PUBLIC INTEREST REVIEW FOR GROUNDWATER APPLICATIONS

TO: Water Rights Section Date 06/05/2018  
 FROM: Groundwater Section Phillip I. Marcy  
 Reviewer's Name  
 SUBJECT: Application G- 18320 Supersedes review of 08/17/2016  
 Date of Review(s)

**A. GENERAL INFORMATION:** Applicant's Name: John & Kathryn Rohner County: Baker

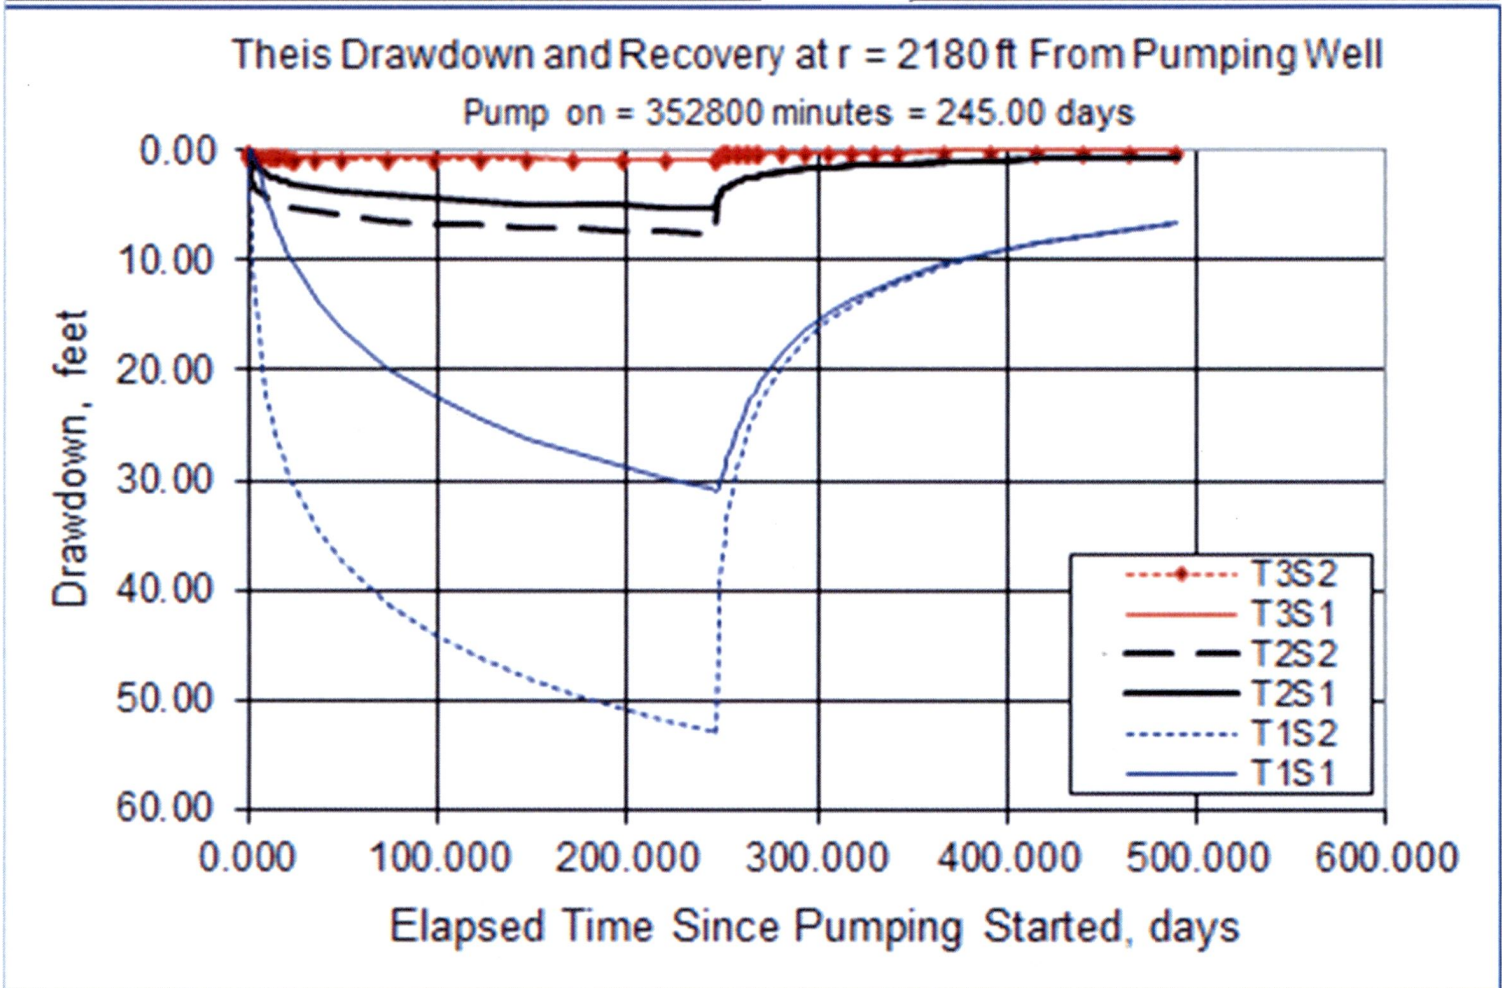
The most likely scenario for drawdown at the nearest POA from the proposed use is that depicted by the solid black line (T2S2), using aquifer parameters that fall within the range of sand and gravel aquifers and those of nearby pump tests.
